Cranbrook High School

Traffic Management Plan

Roadworks road safety audit (plan-based)

PC-PROJ-0003-01 RW RSA CRANBROOK REV 1

Table 2 Road safety audit findings.

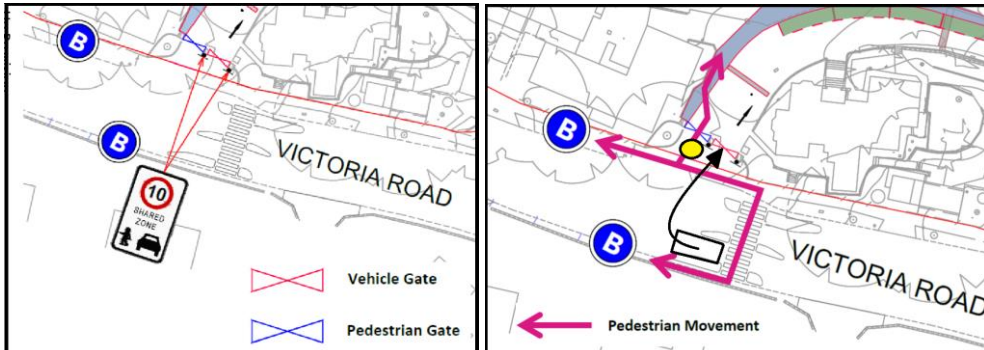
Ref	Location	Road safety audit finding	Priority
1a	General – Safe operation of the drop off and pick up zone.	<p>The drop off/ pick up zone will be positioned in the existing porte cochere stemming off Victoria Road and emerging onto Rose Bay Avenue. An 18-space queuing and pick up line would be established as shown below. The assisted bays would be used mainly by younger students that require assistance when boarding or alighting from vehicles.</p> <p>Much of the success of the assisted drop off/ pick up zone depends on the chain-of-processes involved, the on-site management of students and cars, and the behaviours of the drivers (including queuing behaviour and etiquette). Ideally, under perfect operating conditions during pick up times, vehicles would arrive in bays 1-8 in the designated northbound direction, then load in an efficient manner, and then leave the bays <u>in the same order</u> and proceed to the Rose Bay Avenue gate. This would then allow the vehicles that were originally in bays 9-15 to progress to bays 1-8 and load and leave in the same order. However, in reality the vehicles would not always leave the pick up bays in the same order that they arrived. Similarly, many vehicles would not be ready to leave in the same order if they take longer to load or are required to wait longer. For example, if vehicles 1-7 are loading, but vehicles 4 and 5 are ready to leave well before the others, these drivers may tend to pull out into the circulating lane. This would create additional and unnecessary crash conflicts such as <i>rear-end</i> and <i>side-swipe</i> crashes due to vehicles 4 and 5 pulling out into the circulating lane. There would also be <i>rear-end</i> crash conflicts as vehicle 4 pulls out believing that the circulating lane is free, only to have vehicle 5 pull out at the same time (or even momentarily before).</p> <p>By pulling out of the line before the leading vehicles clear out of the pick up area, it also encourages trailing drivers to pass around the queue to enter those empty spaces. This also creates crash conflicts typical of parking manoeuvres. It would also cause frustration as many drivers would consider this to be “pushing in”, “jumping the queue” etc. Pockets of empty spaces would be more prevalent in the unassisted bays (bays 9-18) as these pick up transactions would be much quicker than the assisted bays.</p>  <p>Above: Extract from the Traffic and Parking Plan showing the designated drop off and pick up bays.</p>	Medium
